I reviewed the schematic and waveforms and have a few comments and suggestions.

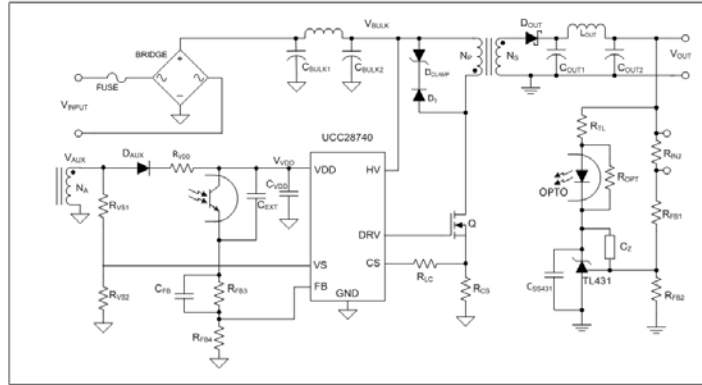
1. The gate drive and auxiliary waveforms signals that you sent appear to be bursting at 62.5 kHz.
 - a. The UCC28740 does not have burst mode.
 - b. This could be a large signal issue or small signal loop stability issue.

2. I don't believe this is an over current fault. I believe it is a large signal or small signal loop stability issue.

3. Possible causes of Large Signal Loop Stability Issues.
 - a. Electronic device not properly setup or biased.
 - b. Things to check
 - i. If VDD was transitioning between the turn on threshold (21V) and turnoff threshold (7.75V) this would indicate a fault. (Input Under Voltage, Over Current, Over Voltage, and Temperature).
 - Double check VDD to ensure this is not occurring.
 - ii. Op Amps and ICs are not properly biased.
 - iii. OpAmp IC202-A/B bias rails should be DC stable.
 - iv. Voltage supping the TPS25740 should be DC stable.
 - v. IC1 input and output voltage should be DC stable.
 - vi. TPS25740 is misbehaving.
 - Check CTL1 and CTL2 voltages for DC stability.
 - c. If any of the above ends being the cause of the issue. The biasing or misbehaving component issues need to be resolved.

4. Small Signal Stability Recommendations.
 - a. To check loop stability you can evaluate the UCC28740 FB pin and the designs output voltage to check for stability.
 - i. They should be DC with very little ripple voltage.
 - ii. If these pins have large signal sinusoidal ripple the cause is most likely small signal loop stability.
 - iii. If these pins have large triangular or square waves on them most likely it is large signal stability issue.
 - b. I noticed the feedback loop was type 3 compensation and you were depending on the opto for the high frequency pole.
 - i. This is not the typical compensation network that is used for the UCC28740. However, it can be used if you use a network analyzer to compensate the voltage loop.
 - c. The UCC28740 data sheet recommends using a capacitor (CFB) across RFB3 (R63 in your design) to filter out high frequency noise.

- i. I notice this design does not have this capacitor. You might consider adding it to make the design less susceptible to noise.
- ii. The data sheet recommends setting this time constant to 1 ms and then fine tune the capacitor as needed.

- a. There is an Excel calculator that you can use to compensate the voltage loop at the following link. <http://www.ti.com/lit/zip/sluc487>
 - iii. Please note that this compensation scheme is slightly different than what your customer is using. However, the board could be modified to support this control scheme just to check to see if it resolves the problem.
- b. If this problem proves to be a small signal stability issue. The following can be done.
 - a. Use UCC28740s recommended compensation scheme with the Excel design tool to compensate the voltage loop.
 - b. Use a network analyzer to compensate the voltage loop.
